# Kevin Rosengren & Associates Pty. Ltd.

### **MACRAES GOLD MINE - FOOTWALL FAULT PEER REVIEW OF PSM REPORT**

This report presents a peer review of the Pells Sullivan Meynink (PSM) report (Ref. 1) concerning likely ground movement on the Footwall Fault, resulting from proposed cut-backs of the Round Hill and Southern open pits. The review is based on information in the PSM report (Ref. 1), together with our knowledge of the area and other information provided by Oceana Gold (NZ) Limited (OceanaGold).

Fig. 15  
 BUTTRESS/PILLAR STATISTICS

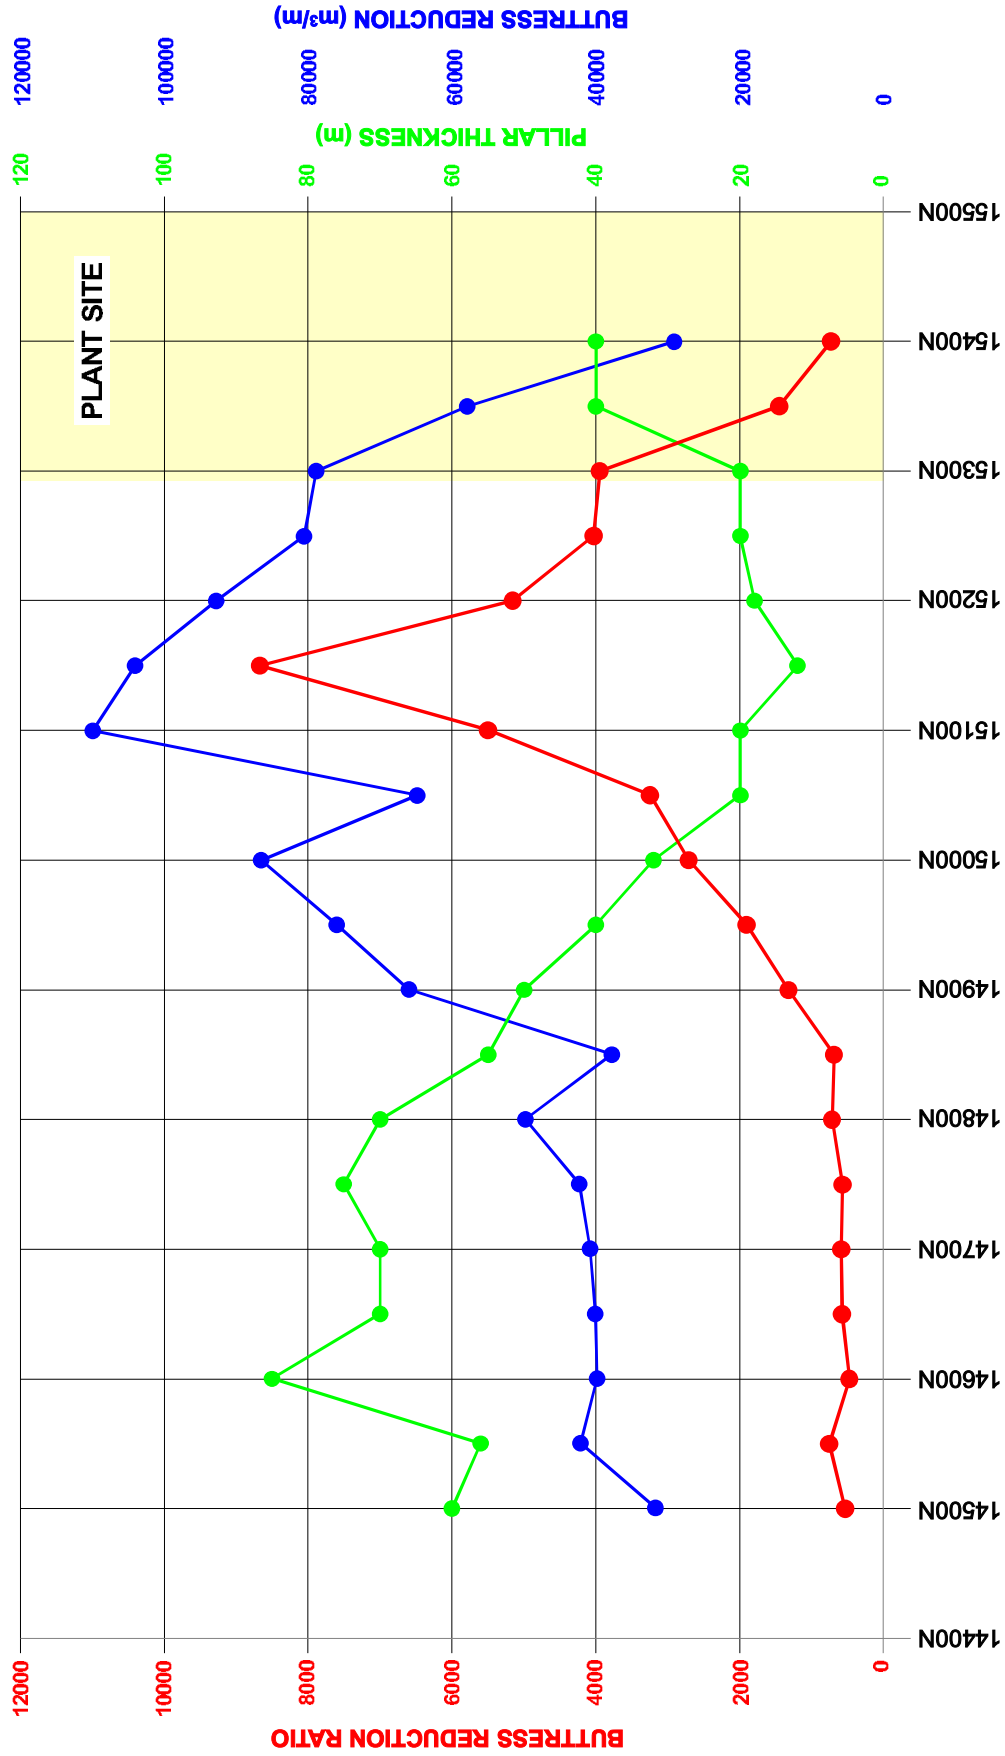
Fig. 15 shows that BR value is low south of 14850N, indicating that footwall ground movements in this area will be relatively small. However, the value is high between 15000N and 15300N, indicating that ground movements in this area will be large. In this area, the Footwall Fault

In our opinion, the movements are likely to be relatively greater than those which have occurred previously because of:

For these reasons, we believe that the movements predicted by the PSM report represent a lower estimate.
